WATERBURY FILING NO. 1 EL PASO COUNTY, CO CONSTRUCTION SET FEBRUARY 2023

EPC STORMWATER REVIEW COMMENTS IN ORANGE BOXES WITH BLACK TEXT

**OUTLET STRUCTURE MODIFIED TYPE 1 MH**  
SCALE: 1"=2'

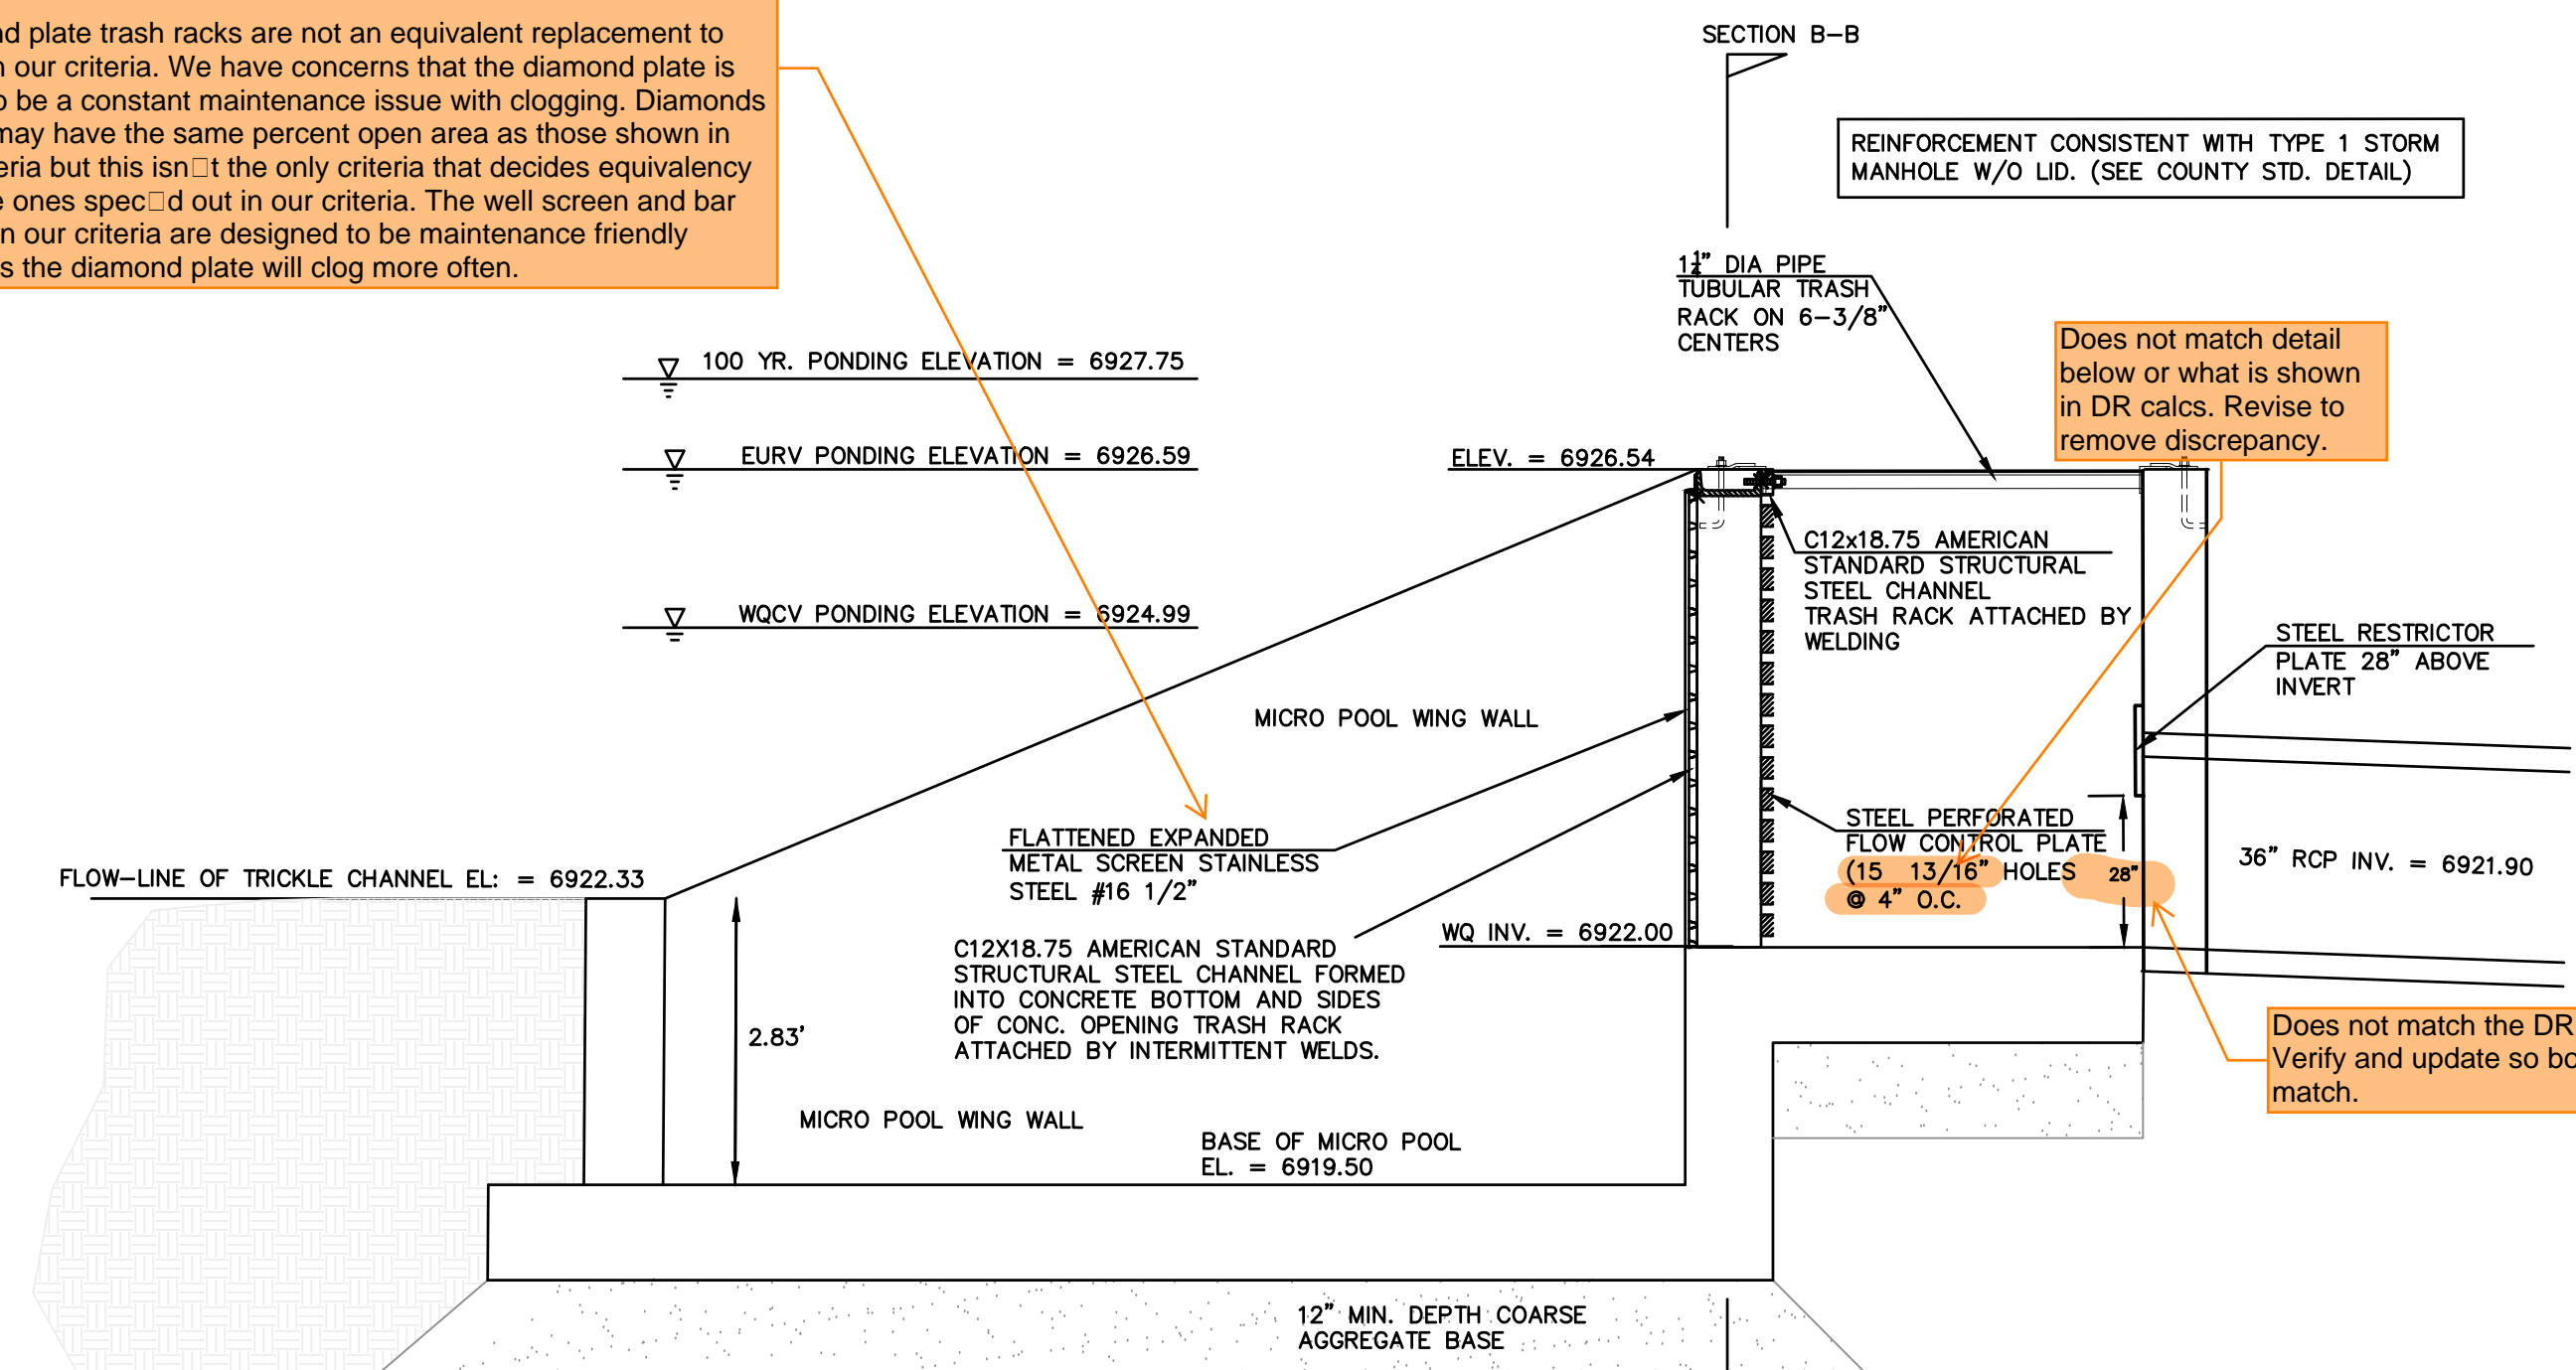
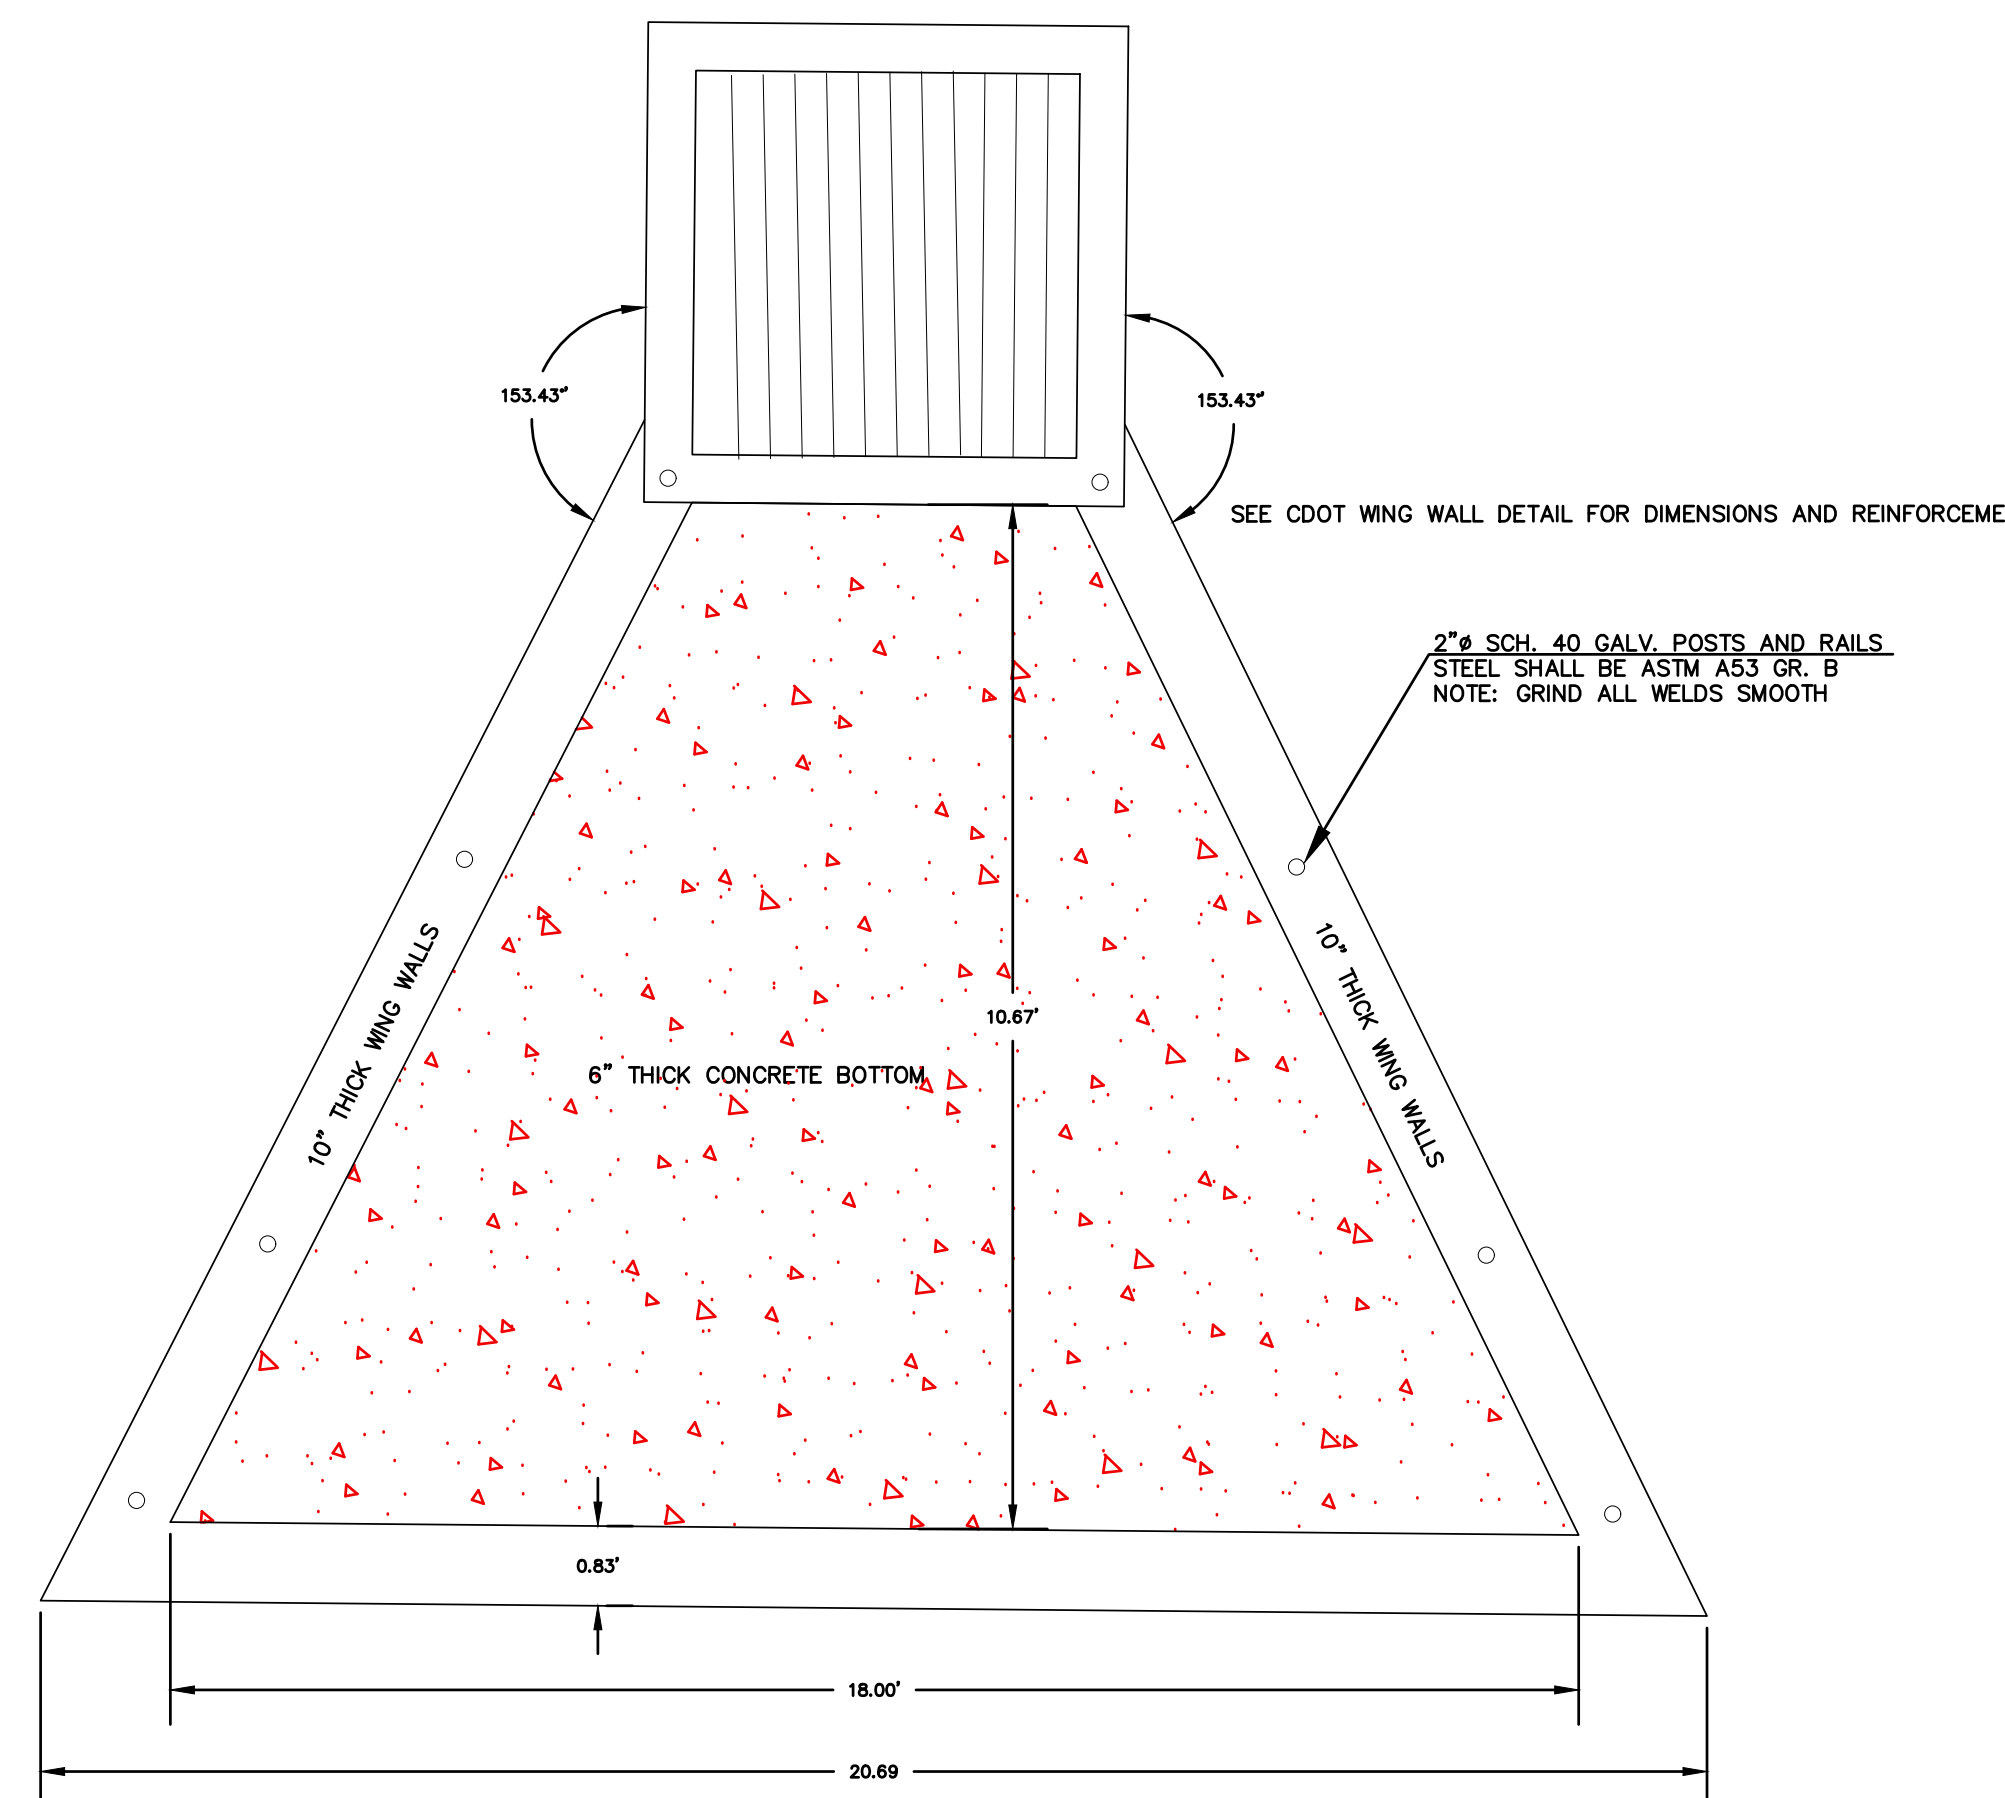
Trash rack to be Amico Klemp KRP Series aluminum bar grate (Figure 6-b), US Filter or Johnson stainless steel well screen with #93 VEE wire (Figure 6-a), or equivalent (per EPC DCMV2, Chap 4.3 and MHFD Detail T-12).
